DEPARTMENT OF NATURAL RESOURCES
DIVISION OF OIL, GAS AND MINING

TO: Susan Linner, Permit Supervisor
FROM: Lynn Kunzler, Reclamation Biologist *L. K.*
RE: As-Built Plans and Site Conditions, North American Equities, Inc., Blazon #1 Mine, ACT/007/021, Folder #2, Carbon Co., Utah.

BLAZON #1 MINE REVEGETATION	
Approximate Areas of Potential Revegetation Problems	
	AREAS OF SLUFFING and/or SLIDING
	AREAS NOT HYDROMULCHED and/or SEEDED
	AREAS OF CONTAMINATED STRAW SCATTERING

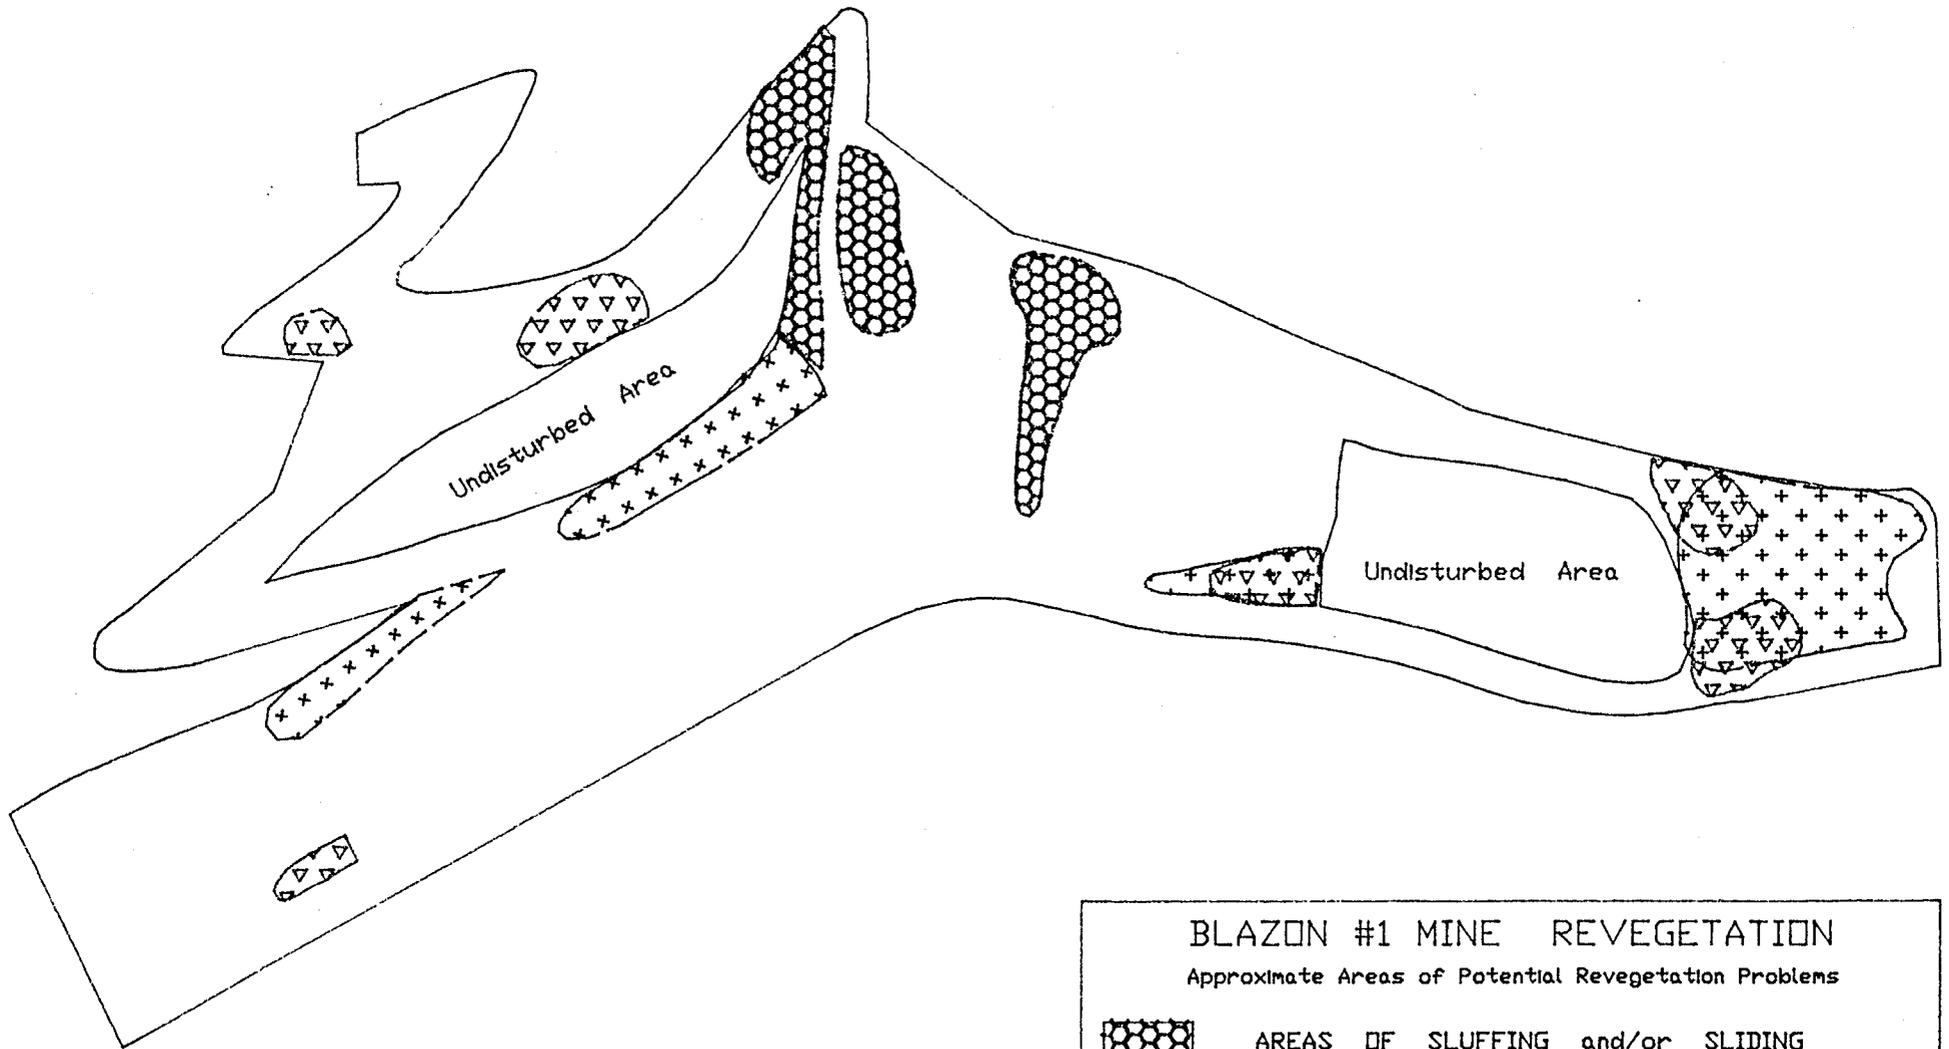
Please refer to the attached drawing entitled Blazon #1 Mine Revegetation for the following comments. Please note, the drawing is not necessarily to scale and the areas depicted represent only the approximate location and extent of revegetation problems. The actual size, shape and location may vary significantly:

1. During the site visits, several areas were noted that have either sluffed/or experienced slides (surface failure). This type of instability generally removes seeded materials and

thus would require retreatment of revegetation practices. Since the area in the Little Snider Drainage experienced sluffing (the area was hydromulched), NAE will need to provide better surface stability such as using curlex blankets as mulch. The slide area on the reclaimed portal slope will need to be revegetated.

2. Several areas were observed in the field that were not hydromulched as required by the plan, including the topsoil storage area and culvert A, the cut slope east of the pad, the disturbed area between the sediment pond and the reclaimed transformer road, and disturbed areas between Mud Creek and the access road. The Division is uncertain at this time whether these same areas were seeded or not. NAE will be required to (sic) reseed and mulch these areas if adequate vegetation does not establish this year (Adequate vegetation in this instance refers to the general level of vegetation on these sites as compared to other revegetated areas and not to meeting the revegetation success criteria). Also, these areas need to be indicated on Plate 1.

3. Several areas were observed where straw had been scattered. As noted in previous correspondence, this straw was contaminated with viable noxious weed seed. Depending on the establishment of the noxious weeds and the type and level of weed control needed, these areas may also require revegetation after weed control.
